Re: Task 3 Dam Assessment Report
Project #0-381
Allen Steam Station Coal Ash Retention Dam
Belmont, North Carolina

EXECUTIVE SUMMARY

ALLEN STEAM STATION COAL ASH RETENTION DAM
BELMONT, NORTH CAROLINA

#35 Seepage Collection Area Near Maximum Section of Downstream Toe of East Dike

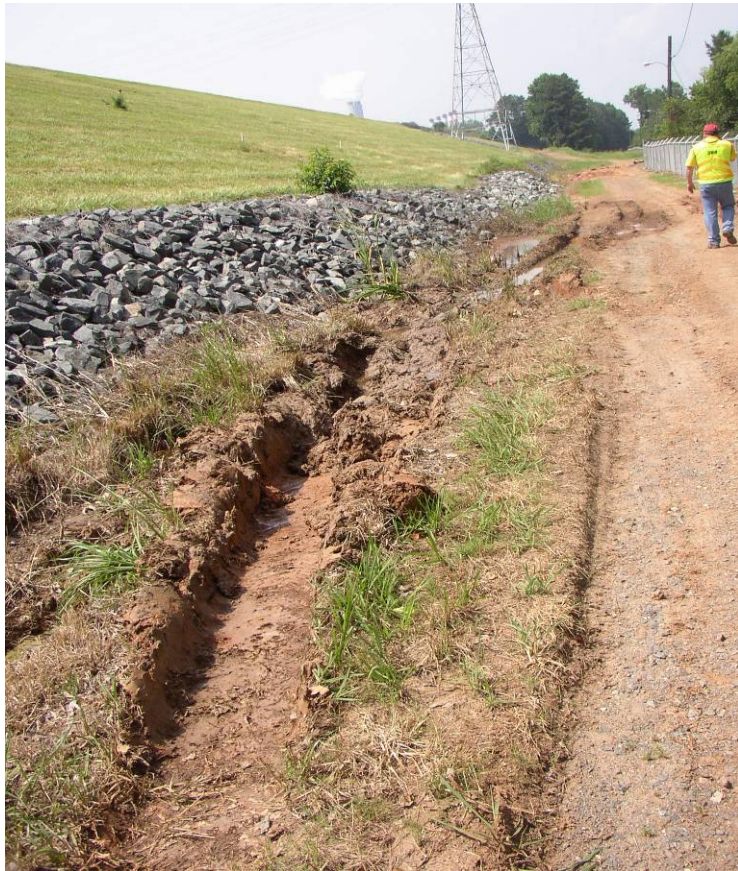
During the visual inspection, potential seepage was observed as part of the downstream blanket drain system along the toe of the North Dike Berm and near the maximum section for the East Dike.

4. Observations of the upper downstream toe of the East Dike should be made during periods of low rainfall to determine whether the standing water observed at the toe was due to surface water runoff or internal seepage. Seepage conditions should be monitored regularly.

#54 Downstream Slope of North Dike (Note Evidence of Prior Scarps)

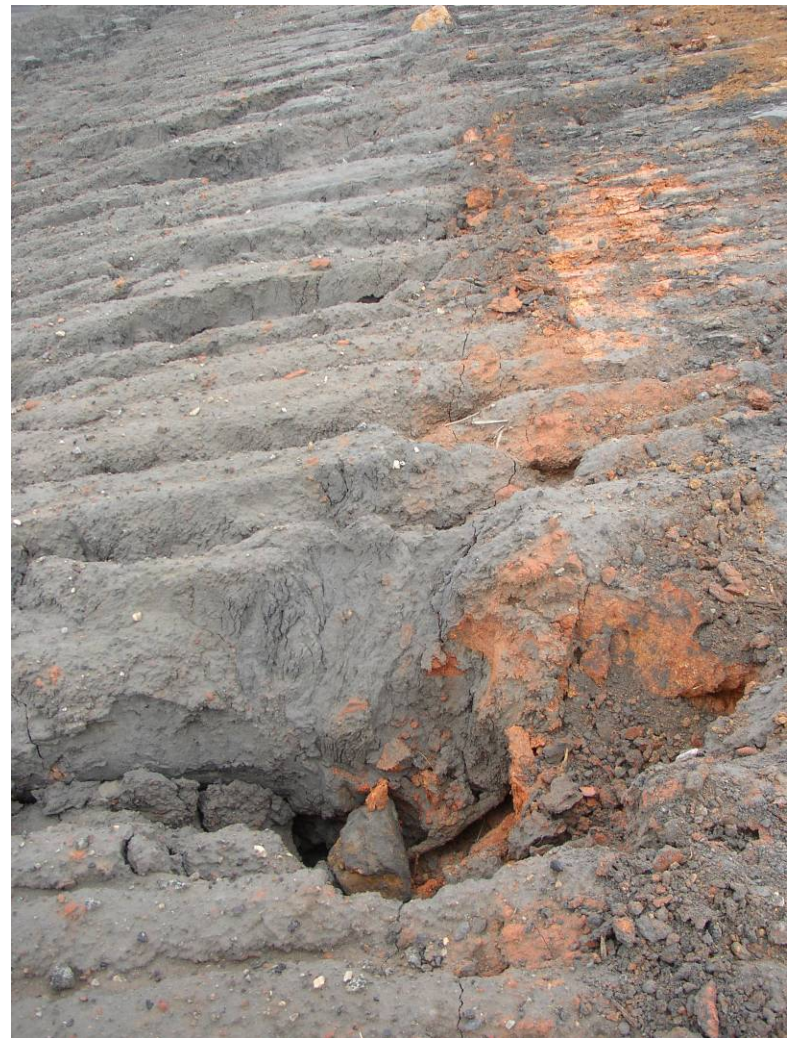
Minor scarps have historically been observed on the upper part of the downstream slope. These scarps are located several feet below the crest and are attributed to shallow slip failures within the upper layers of soil. The scarps remain on the embankment, and appear to have caused minor bulging in the lower section of the 2H:1V slope (above the stability berm). The ongoing construction activity in Cell 1 has also created ruts on the downstream slope at the western end of the North Dike.

2. Engineered maintenance repairs of the scarps should be undertaken and a monitoring program implemented to detect potential stability or seepage issues.
